MFN 06-407
Supplement 13

Subject: Revised Response to Portion of NRC RAI Letter No. 166 Related to ESBWR Design Certification Application - DCD Tier 2 Section 3.8 – Seismic Category I Structures; RAI Number 3.8-94, Supplement 3

Revised Response to Portion of NRC RAI Letter No. 166

RAI Number 3.8-94 S03 (Revision 1)

Figure 3.8-94(26) FRS (Compared with the DAC3N) – FPE Top Y

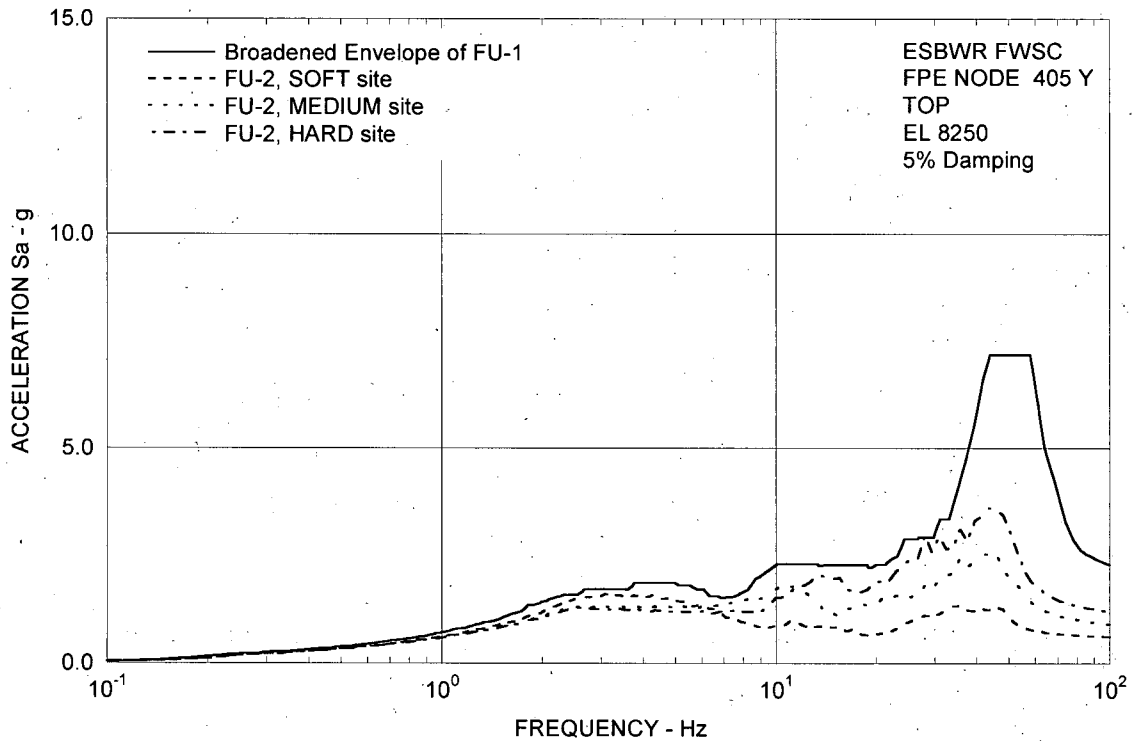
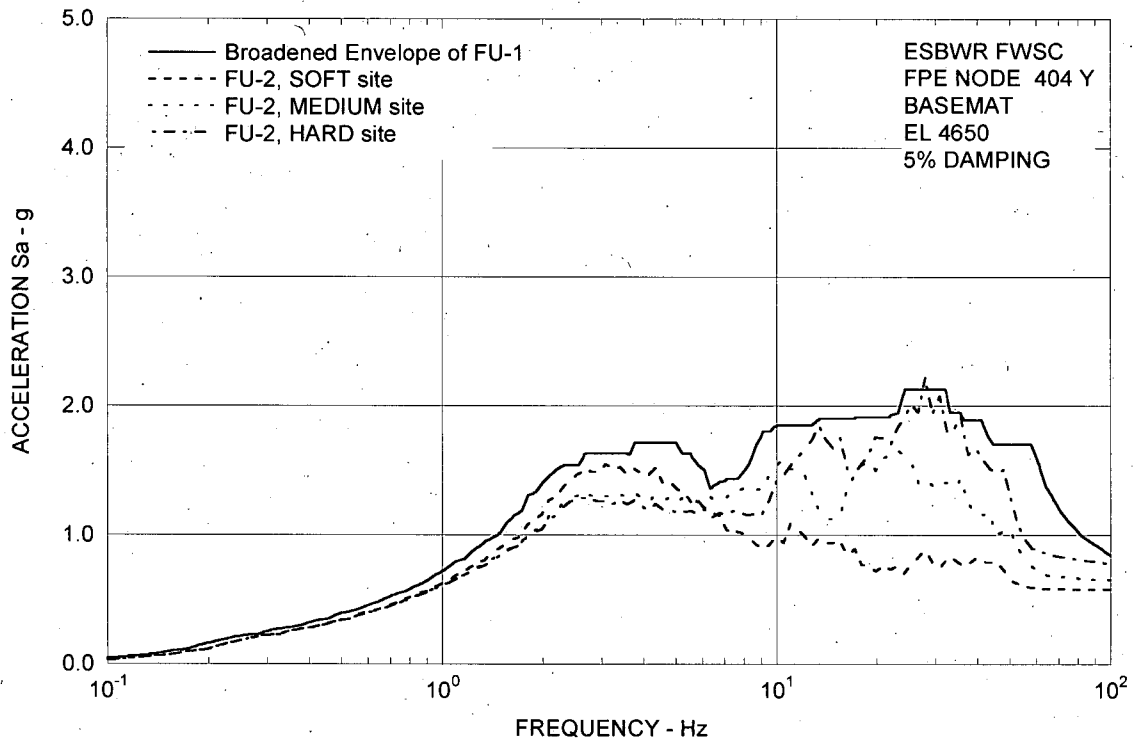
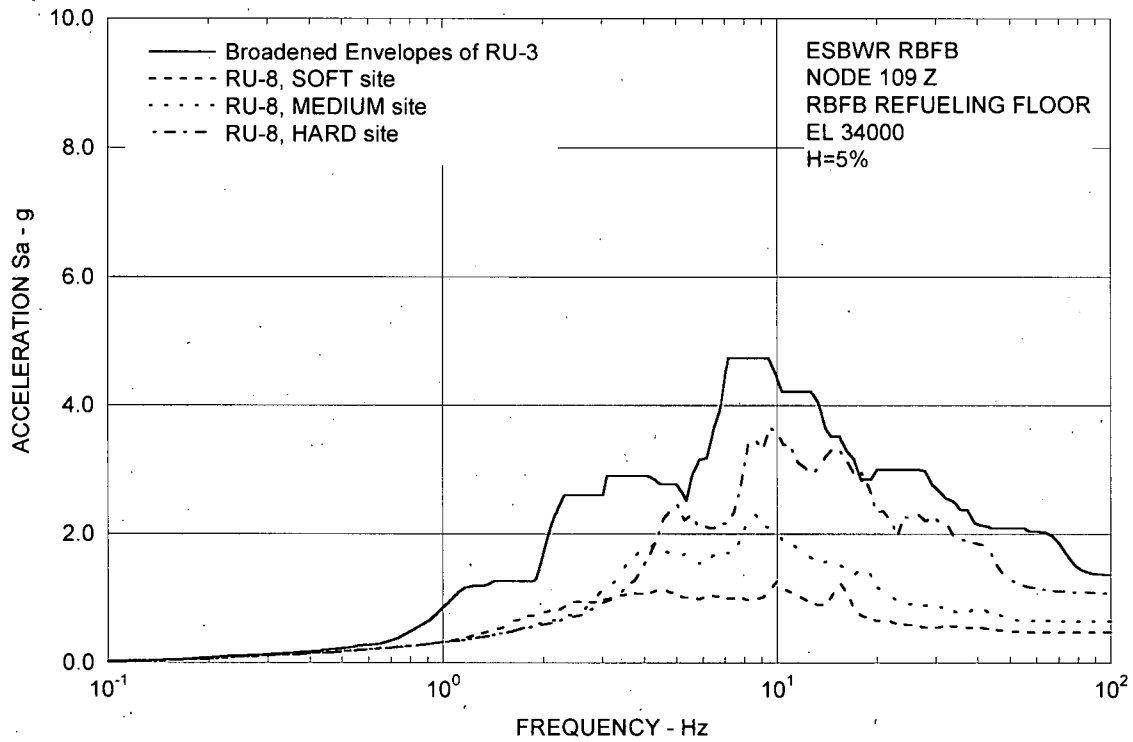
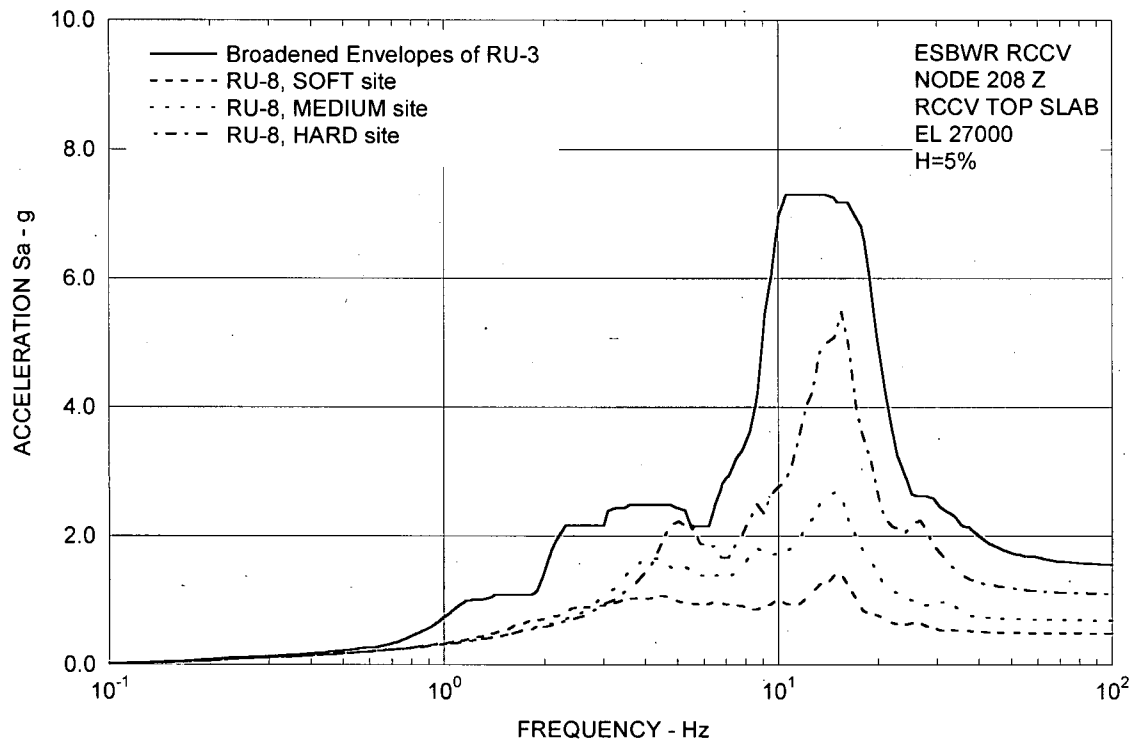
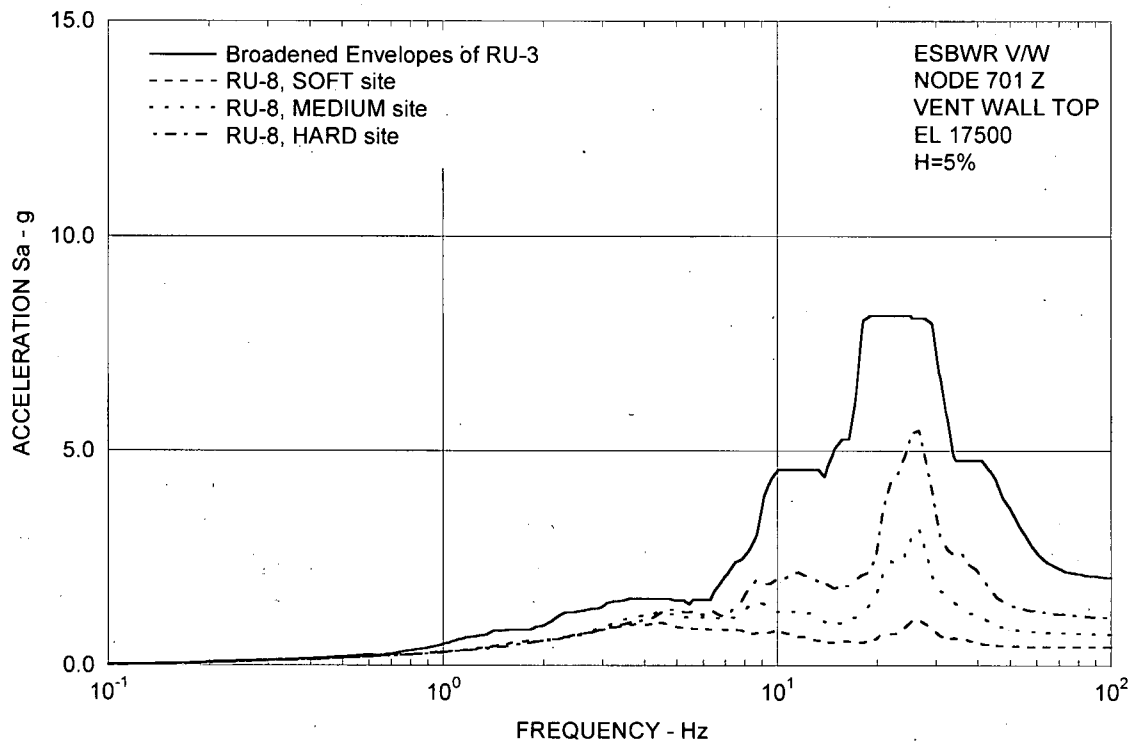
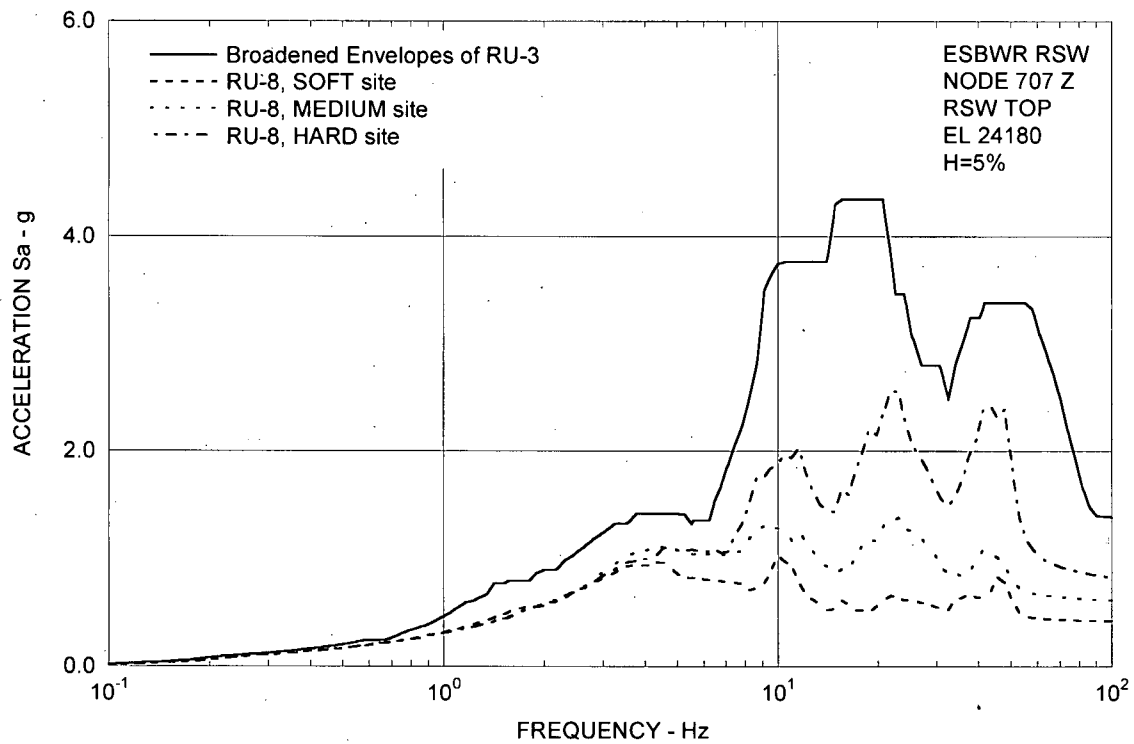
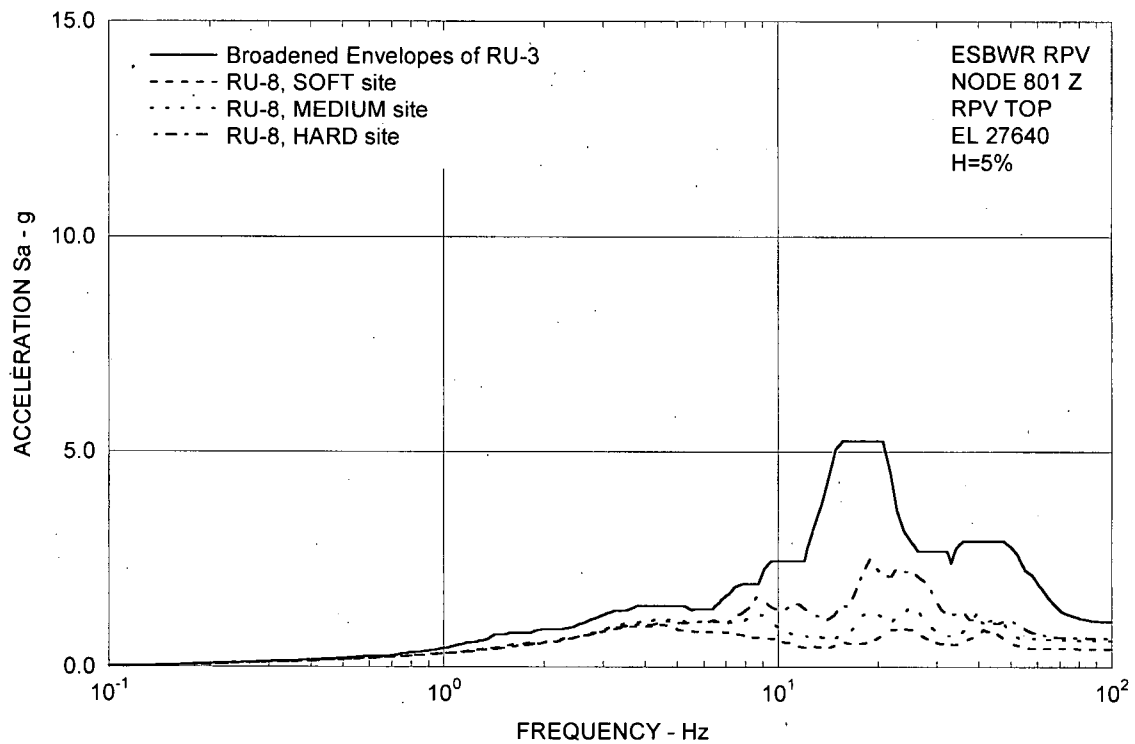
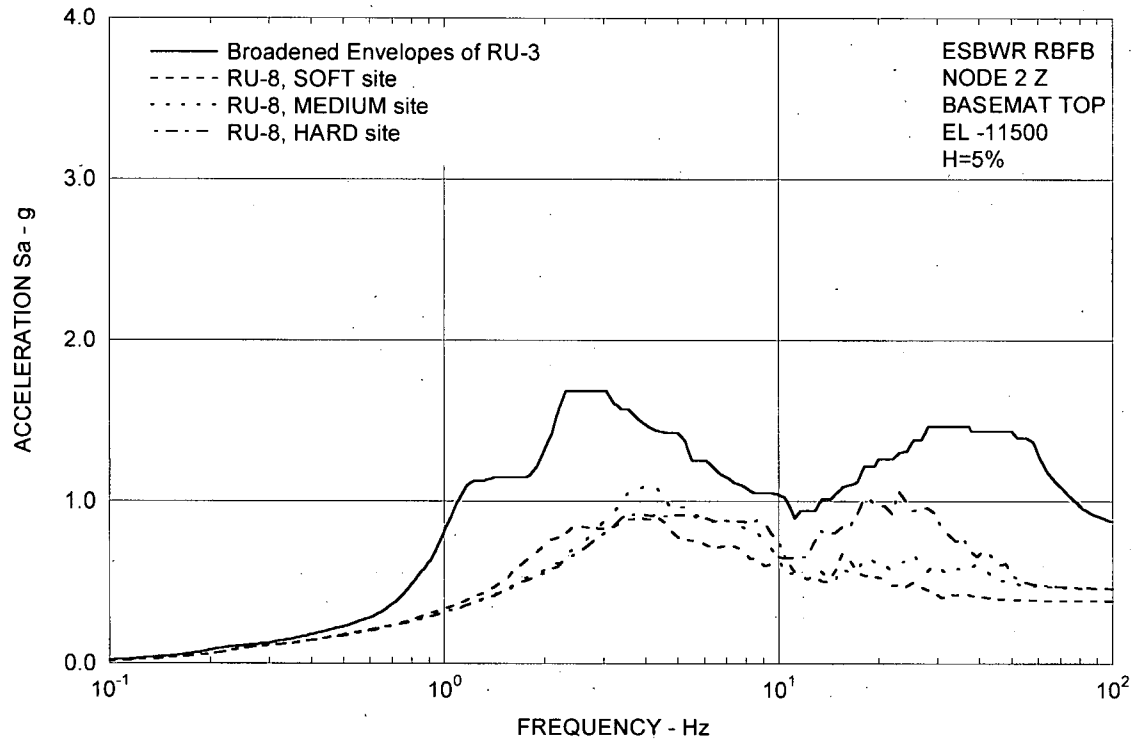
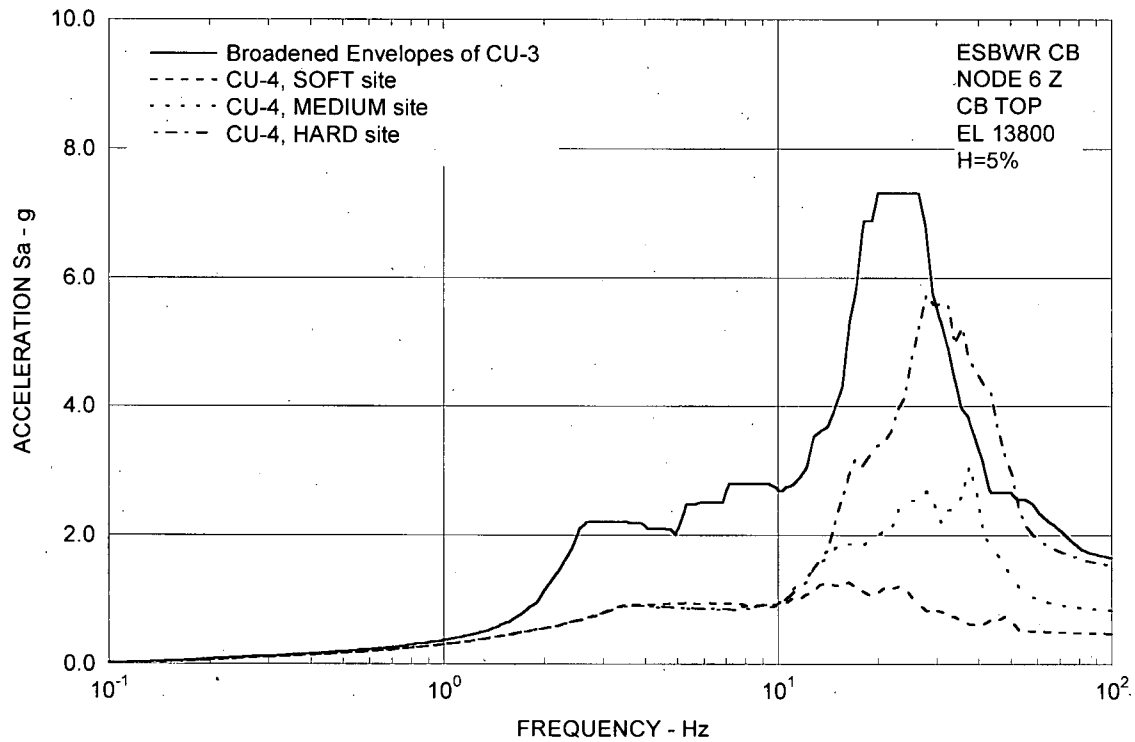
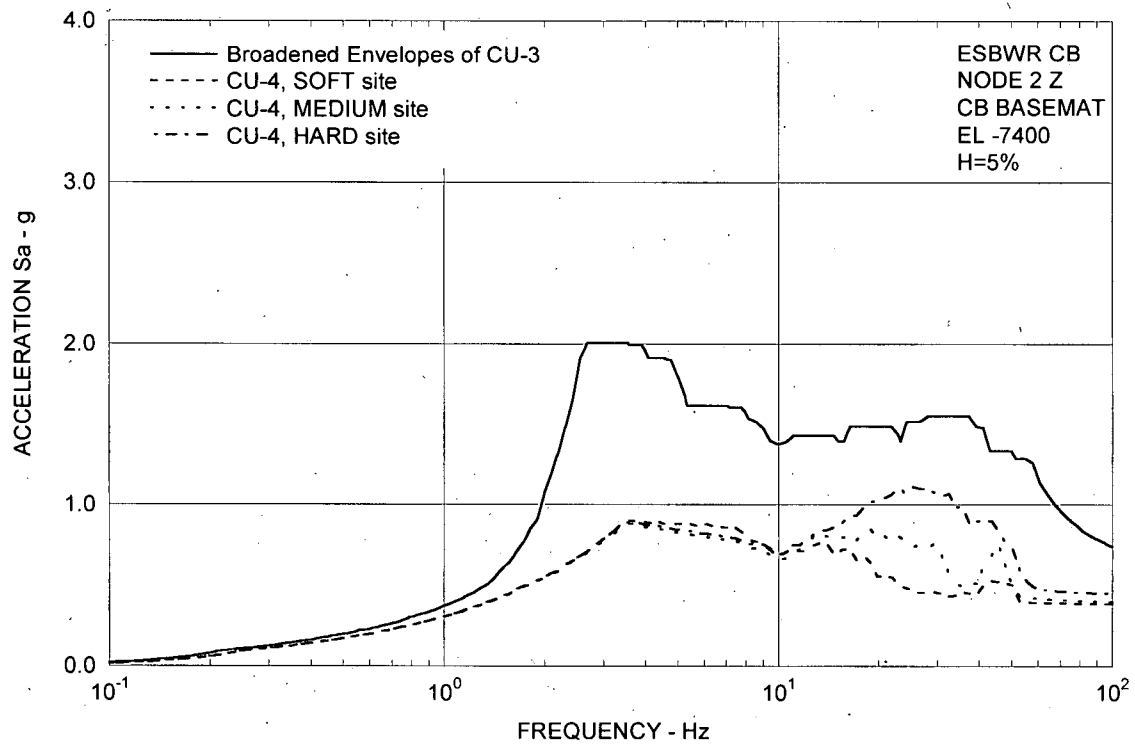
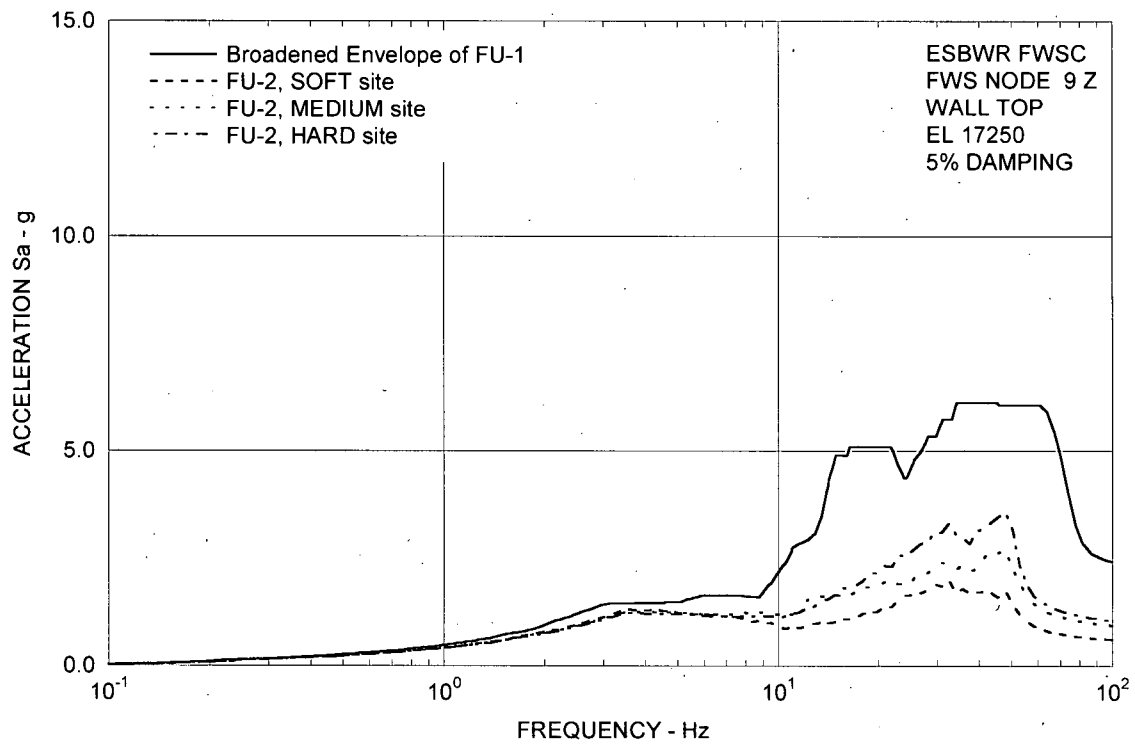
Comparisons of the response spectra are shown in Figures 3.8-94(4) through 3.8-94(15), Figures 3.8-94(16) through 3.8-94(27), and Figures 3.8-94(28) through 3.8-94(39), respectively for the X direction, Y direction, and Z direction. These comparisons will be added in DCD Revision 6 as DCD Tier 2 Figures 3A.8.7-1a through 3A.8.7-3l.

As for the RB/FB, it is found from the results that the responses for the SASSI2000 uniform cases are bounded by the broadened envelope responses of the DAC3N cases in the whole frequency range. The responses of the RU-8 uniform hard site at the vent wall top (X direction per Figure 3.8-94(6)) and the refueling floor (Z direction per (Figure 3.8-94(28)) at around 20 Hz are slightly higher around 20 Hz but the exceedance is negligibly small.

On the other hand, the response spectra of a portion of the CB above ground and the FPE in the FWSC exceeded greater than 10% at the broadened envelope responses of the DAC3N cases in the higher frequency range.

Thus, the SASSI2000 uniform site results of the CB and the FWSC are included where appropriate to obtain the enveloping design spectra. DCD Tier 2 Figures 3A.9-1g, 3A.9-1l, 3A.9-2g and 3A.9-3g will be revised in Revision 6 accordingly.
